Enclosure 7 to E-54692

**CoC 1042 Amendment 2, Revision 1
UFSAR Changed Pages**

Figure B.1-1

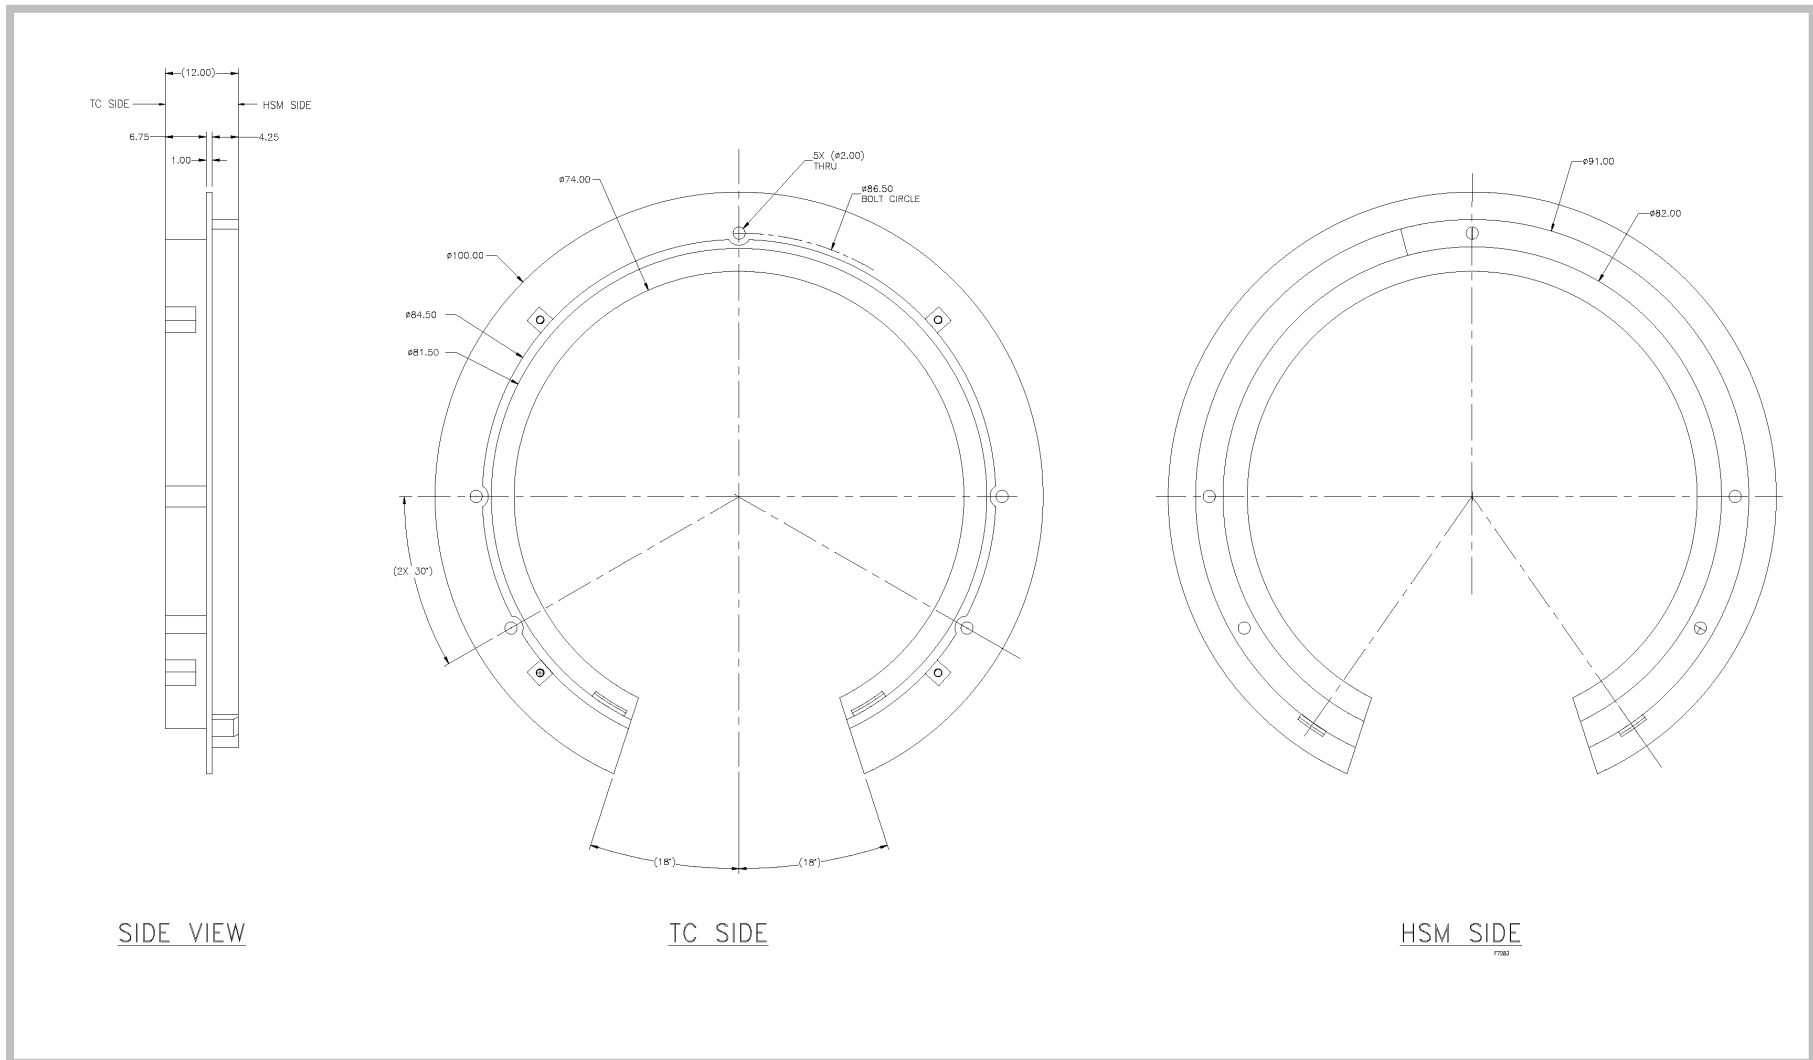
To account for the difference between the OS197 top flange diameter and the EOS-TC diameter, an HSM-MX transfer cask (TC) adapter may be mounted to the door recess of the HSM-MX, *see Figure B.1-1. The adapter interface is designed mainly to aid in TC/HSM alignment as well as protect workers from radiation shielding between the OS197 and the HSM-MX door opening during transfer operations.* Dose rates and occupational exposure in Chapter B.6 and Chapter B.11 are reported without the HSM-MX TC adapter; therefore, the use of this item is mainly for *alignment and* ALARA purposes.
